February 6, 1984

Docket No. 50-423  
B11026

Millstone Nuclear Power Station, Unit No. 3  
Probabilistic Safety Study (PSS)

FIGURE 720.41-1. MEDIAN RESPONSE SPECTRUM AND "EQUIVALENT" PEAK GROUND VELOCITY

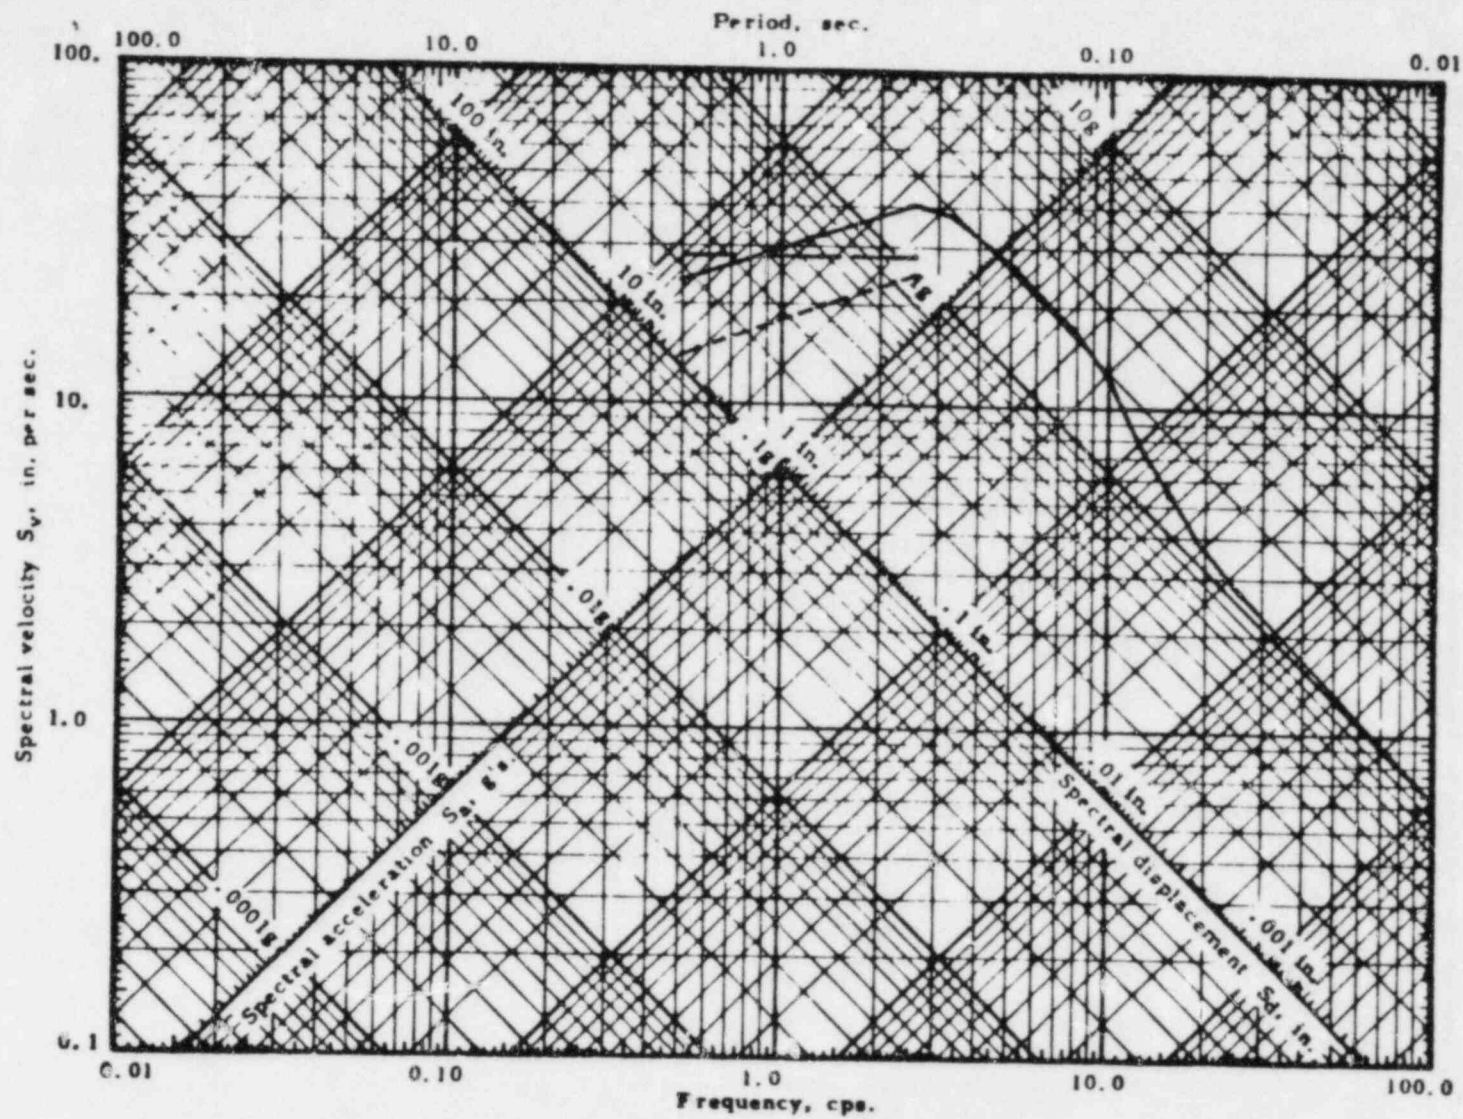
Question 720.42: As stated in Appendix 2-1 (3.4.1), the "fifty percent design spectrum" for rock-founded structures contained in WASH-1255 was used to calculate the spectral shape factor (FRSS). What value of  $v/a$  did you use? Justify this value in light of the recommended value of  $v/a = 36$  in/sec/g in NUREG-CR/0098. Would a change in the  $v/a$  value effect your estimate of the spectral shape variability?

Response: Site-specific response spectra were not available for the Millstone 3 site. The spectra chosen by SMA as representative broad band spectra for the site were derived from Reference 1. These spectra were generated from a data set of earthquakes having magnitudes between 5.3 and 6.3. This magnitude range is expected to contribute the most to the seismic risk. The spectra used are therefore considered more appropriate for definition of the Millstone 3 seismic fragilities than either the WASH-1255 or NUREG-CR/0098 spectra which include earthquakes of greater magnitudes.
